**DEVIATION REQUEST** (Attach diagrams, figures, and other documentation to clarify request)

A deviation from the standards of or in Section **2.6 Structure Design** of the Engineering Criteria Manual (ECM) is requested.

A request allow for multiple pipe crossing (i.e. parallel culverts) for Culvert B6-A, triple 36-inch RCP culverts to allow for the proposed roadway to cross over a shallow and wide natural drainageway.

**OVERLOOK AT HOMESTEAD FILING NO. 1**  
 EL PASO COUNTY, COLORADO  
 CONSTRUCTION DOCUMENTS  
 OVERALL SITE PLAN

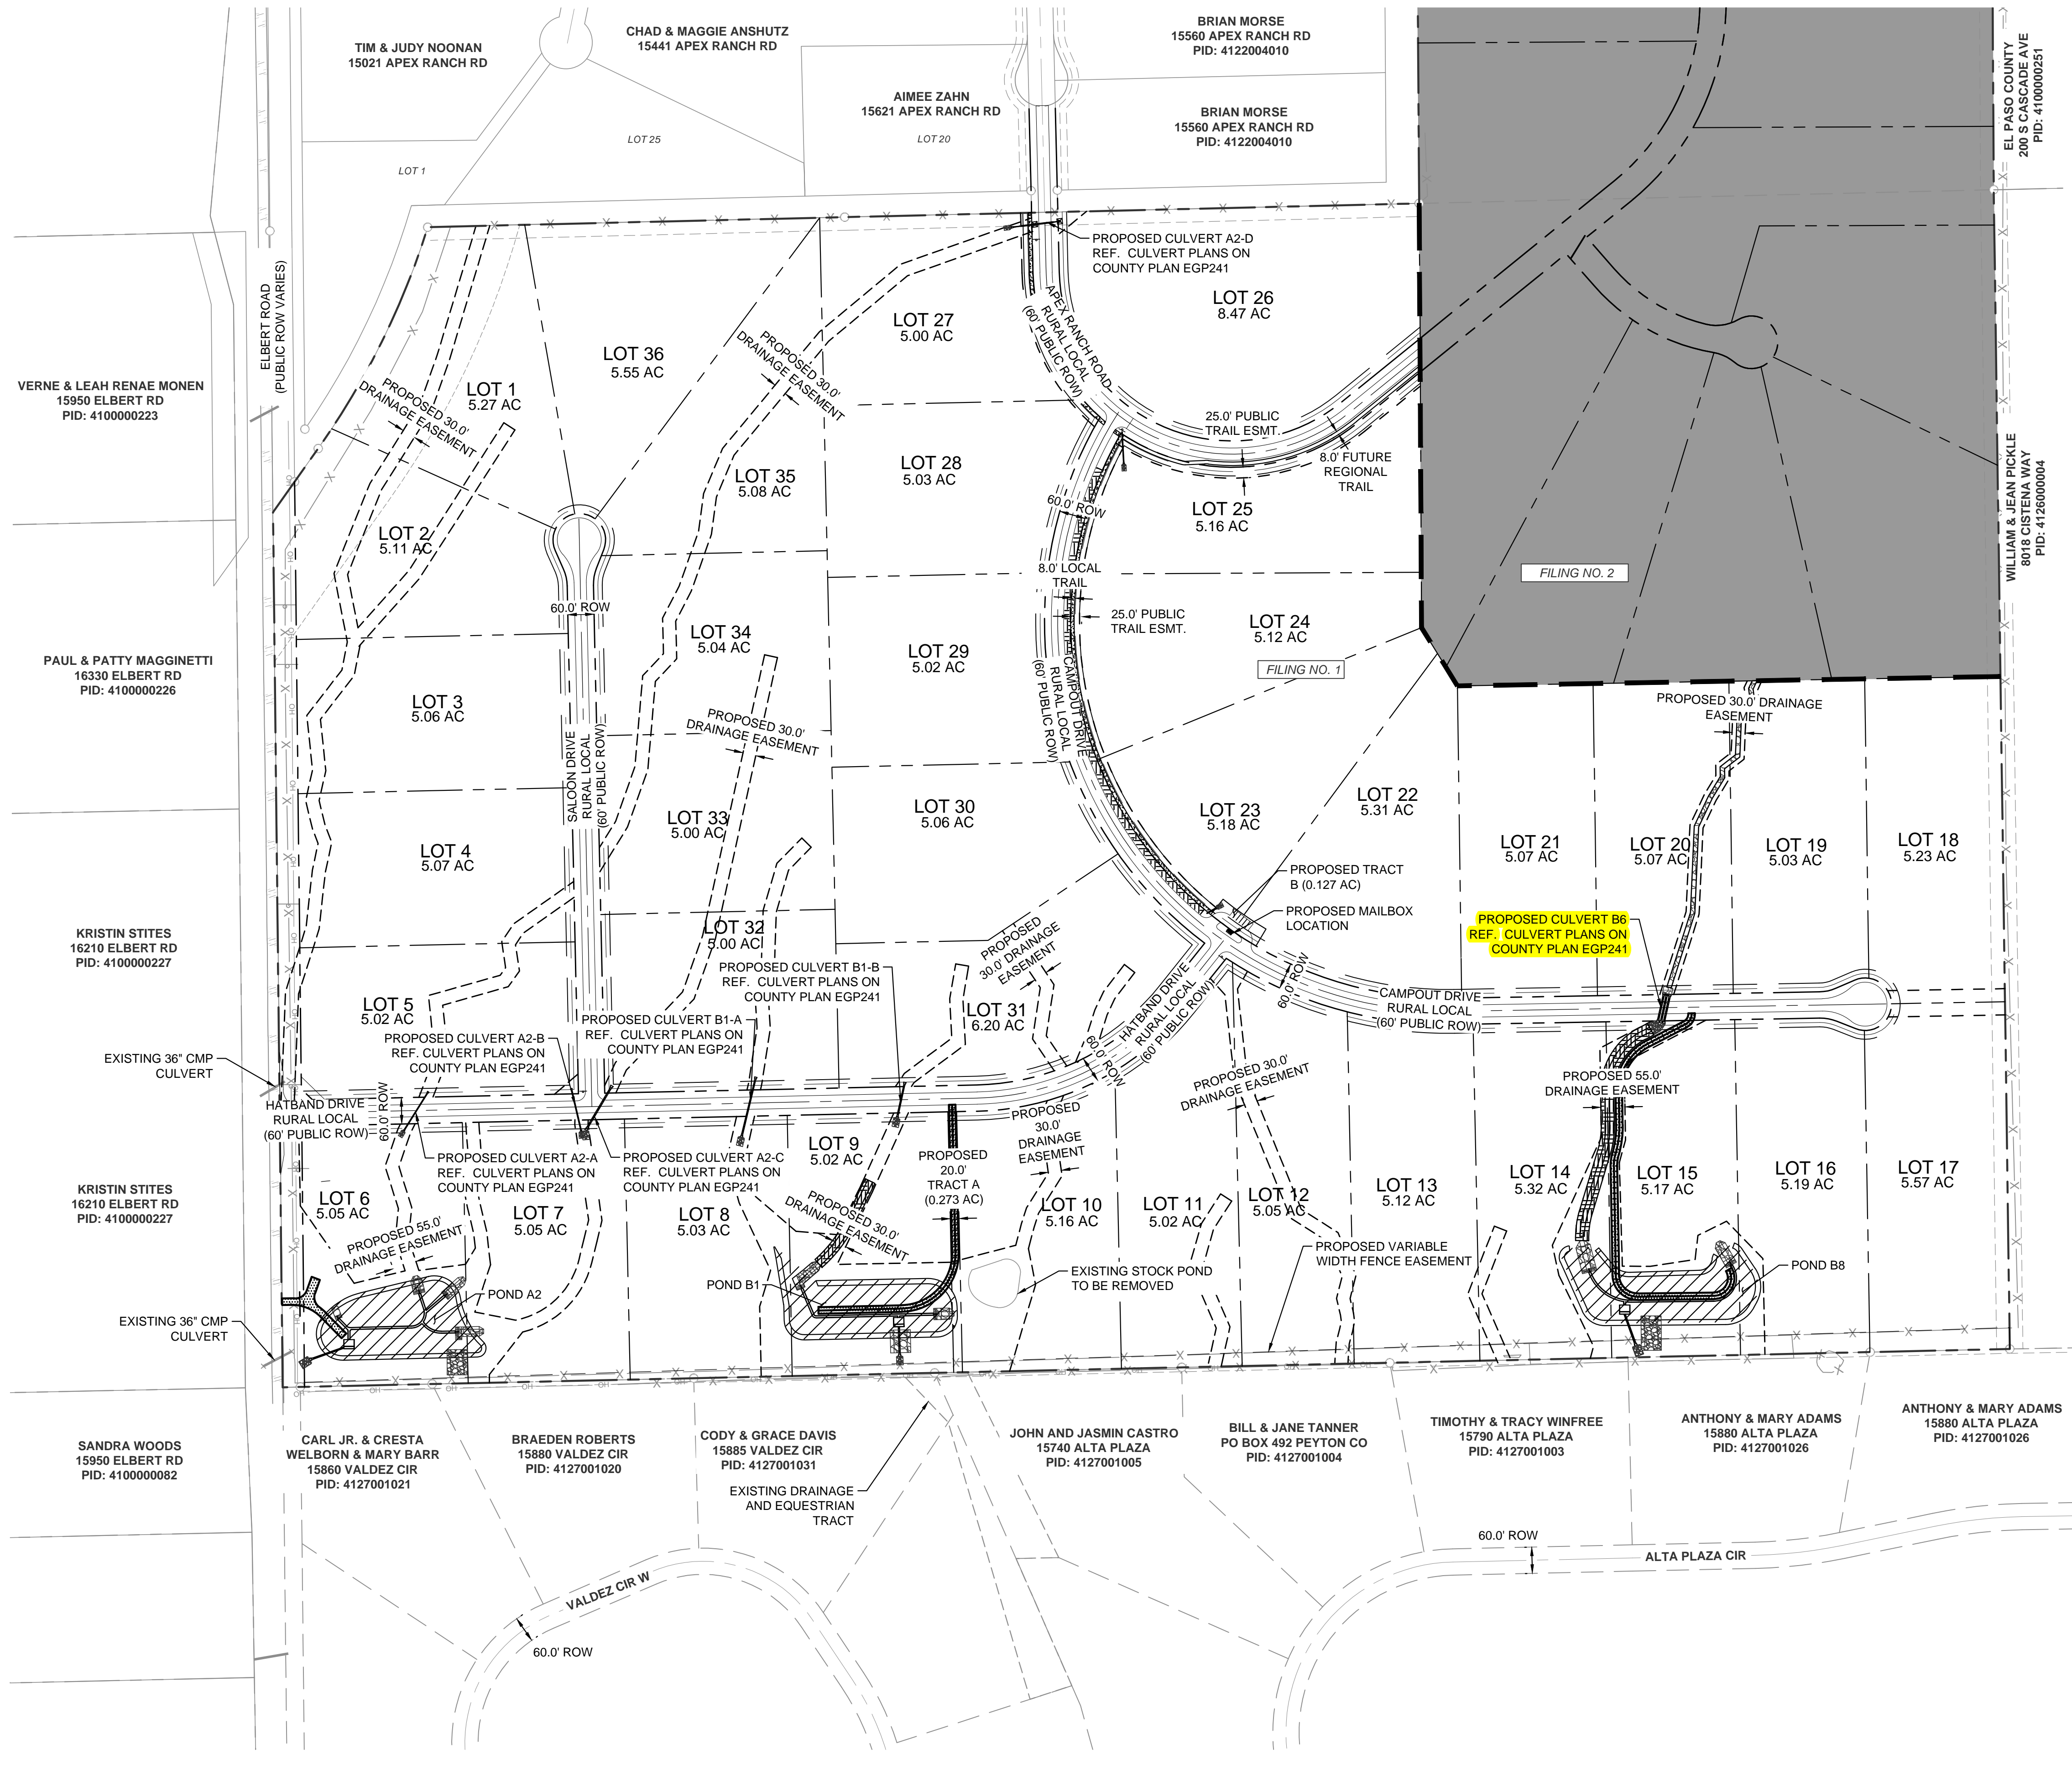
The request proposes allowing for triple 36-inch RCP culverts in place of a single larger culvert. Allowing for multiple culverts (parallel culverts) is a standard practice allowed by CDOT and other jurisdictions that allows for flexibility in design for more constraining locations. This multiple pipe crossing proposes to follow the CDOT standards as outlined in Section 9.2.3-Design Features of Chapter 9 of the CDOT Drainage Design Manual. The pipes will be spaced at the minimum spacing identified in the CDOT Standard Detail M-206-1. An exhibit showing the design and location is provided attached to this deviation request.

- The existing drainage way is wide and shallow. At the location of the culvert, the drainageway starts to transition from a small concentrated drainageway to an approximate 100' wide natural channel way, in more a sheet flow type condition. Crossing a shallow and wider channel lends to a design with a smaller culvert diameter to avoid large amounts of fill.
- Proposed design maintaining the 2-foot minimum cover over the proposed pipe.
- Without a triple barrel, a 54" pipe would be required, causing 1.5' feet of additional fill to the roadway.
- Meet the criteria outlined in the CDOT Drainage Design Manual outlined in Section 9.2.3
- The pipes will be spaced at the minimum spacing identified in the CDOT Standard Detail M-206-1.
- Upstream riprap is being placed on the inlet side to help dissipate any energy prior to entering the culvert.
